of Plan Change 93 (Te Puna Springs) to the Western Bay of Plenty District Plan

**STATEMENT OF EVIDENCE OF NEILL EMERSON RAYNOR
ON BEHALF OF TE PUNA SPRINGS ESTATE LIMITED
(SUBMITTER 04)
23 JUNE 2022**

Figure 2 - Revised Structure Plan

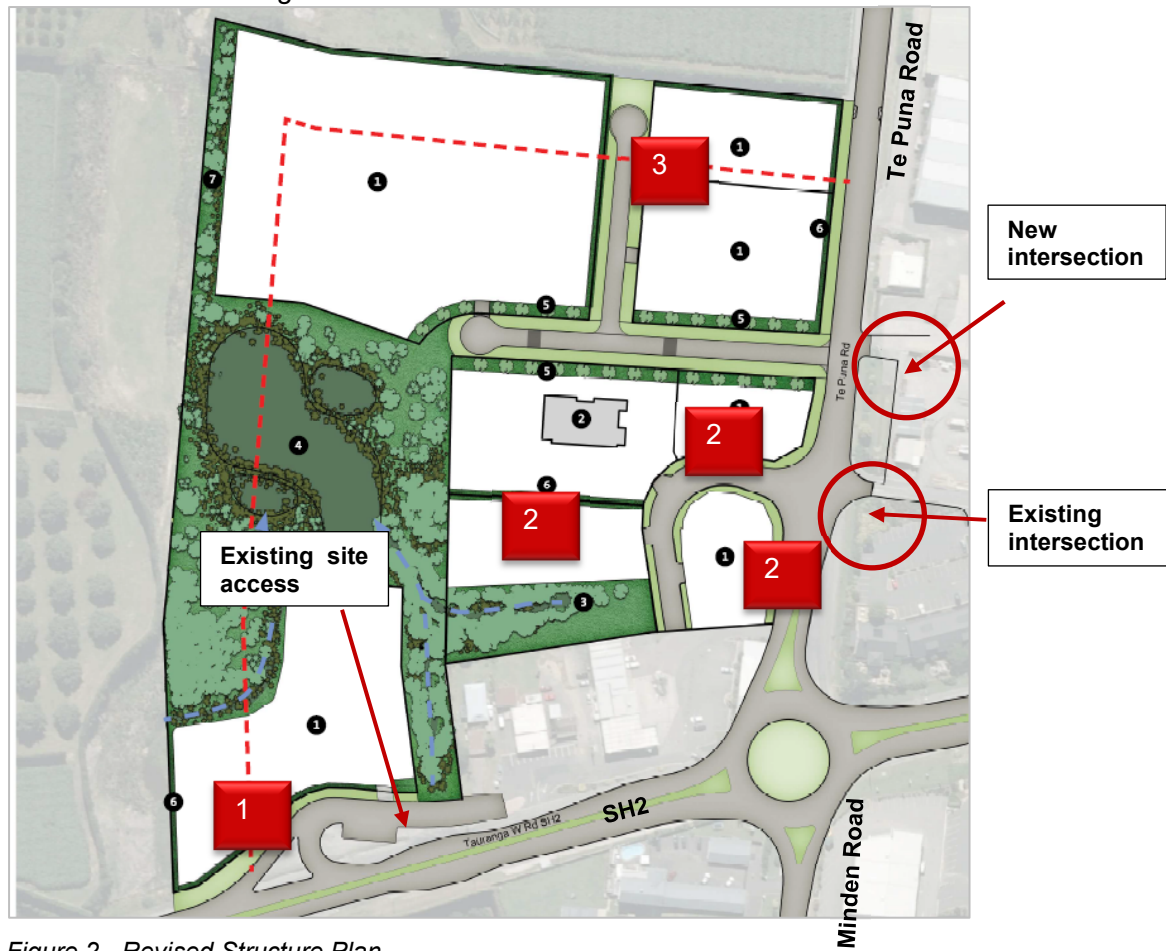
No issue is raised by our freshwater ecologist as to the assessment of values identified for the various waterbodies on the site and we welcome the suggested changes revised zoning layout, however, in the absence of considering a the Best Practicable Option for managing stormwater, further amendments to the extent of the zoning maybe required. In any case, there are a number of inconsistencies between the maps by Wildlands (Figure 2) and Boffa Miskell (Structure Plan Revision L) with regards to stream locations and plot locations.

For stream location, the Boffa Miskell report is more accurate, but still inconsistent with actual stream location as our ecology has mapped them for the South Tributary and Southern Reach. This has implications for accurately understanding buffers being provided and whether stream diversions will be required as part of the development. It is recommended that the applicant should provide an accurate map for the proposed development footprint and current stream locations so we can understand the implications of the development.

In addition to the above, the following matters are raised with regards to the proposed stormwater mitigation identified in the structure plan.

- Parts of the proposed s/w infrastructure is located on-line and would be contrary to the BoPRC stormwater management guidelines (Guideline Document 2012/01; updated at as December 2015). Further, the online detention pond presents a high risk of causing a barrier to fish passage and is likely to force any future consent to have a conflict between managing flood volumes and ensuring fish passage.

- The specific design of the stormwater pond exceeds the maximum pond depth recommendations and could be considered a safety hazard and is considered inconsistent with the Regional Natural Resources Plan and the BoPRC stormwater management guidelines (Guideline Document 2012/01; updated at as December 2015).

- Additionally, the length to width ratios of the two smaller stormwater treatment and extended detention ponds is inconsistent with the BoPRC guidelines and is unlikely to achieve the minimum treatment requirements as laid out in the guidelines.

- The proposed stormwater pond is inconsistent with the BoPRC guidelines for stormwater wetlands over stormwater ponds due to their superior contaminant removal benefits and to avoid long term effects of heating the water and affecting the ecological values downstream.

In relation to Keith Hamills comments on the stream locations, these have been considered and we can make some minor adjustments to the overall plan.

Figure 4 - Overall Catchment and site catchment at Armstrong Road Culvert

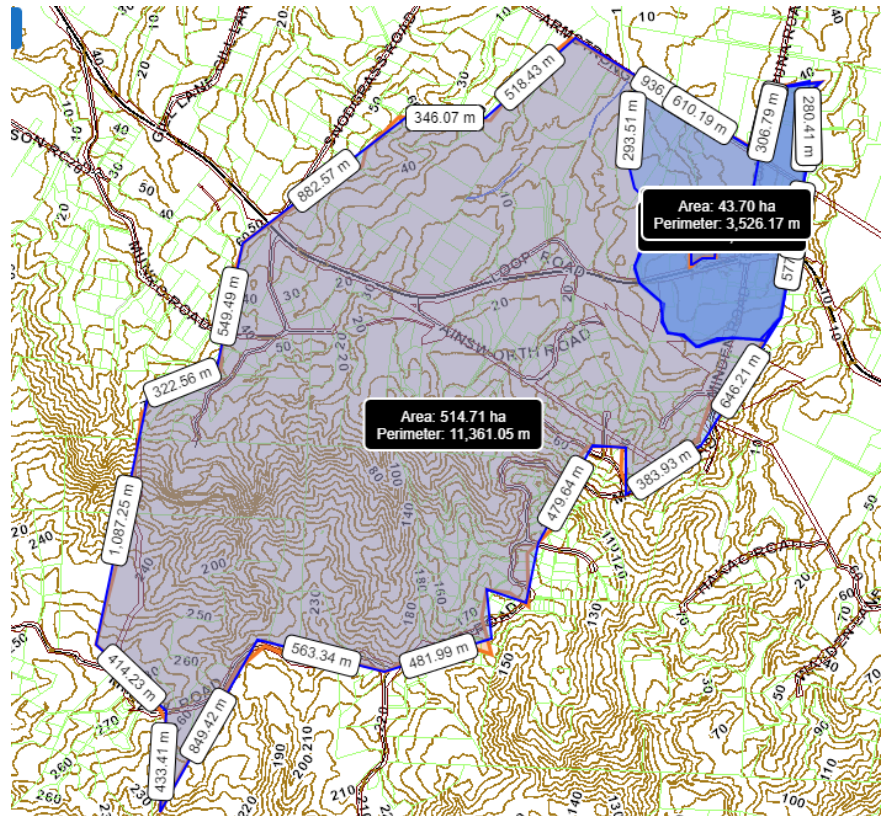
We note that the Western Bay District Council has elected not to seek a risk assessment to manage flood risk. Notwithstanding this, BOPRC's engineers do not consider modelling that has been used to determine the effects of the plan change has comprehensive assessed the cumulative stormwater effects from the surrounding area.

For this reason, BOPRC do not support the level of and, feasibility, of the necessary mitigation to manage the unassessed cumulative stormwater effects from the surrounding area and, are unable to determine whether there is an increase in risk outside of the development site as required by Policy NH 4B, including existing downstream infrastructure including Armstrong Road and Borrell Road.

- 6.22 By a visual comparison of the catchment area with topographical information shown, there is a large proportion of the catchment to Armstrong Road that is of greater distance away and therefore likely to be delayed in terms of the peak discharge arriving at the road culvert.

- 6.23 As there is some attenuation within these catchments from road crossings, low lying flood plain areas, etc, a catchment wide analysis may support a reduced level of attenuation on the site to reduce the delay in peak discharge associated with attenuation, so that it does not arrive at the downstream infrastructure at the same time as the balance of the larger catchment. The existing pond however already delays the peak by approximately 20min so the peaks currently would be almost aligned.

- 6.24 Overall however as the site forms only 1.2% of the overall catchment at Armstrong Road, and the increase in runoff from the plan change area would be less than 1% of the flow at Armstrong Road, the sensitivity is minimal in terms of the overall catchment, but would have an

improvement on the sizing of the infrastructure on site to achieve the necessary levels of attenuation.
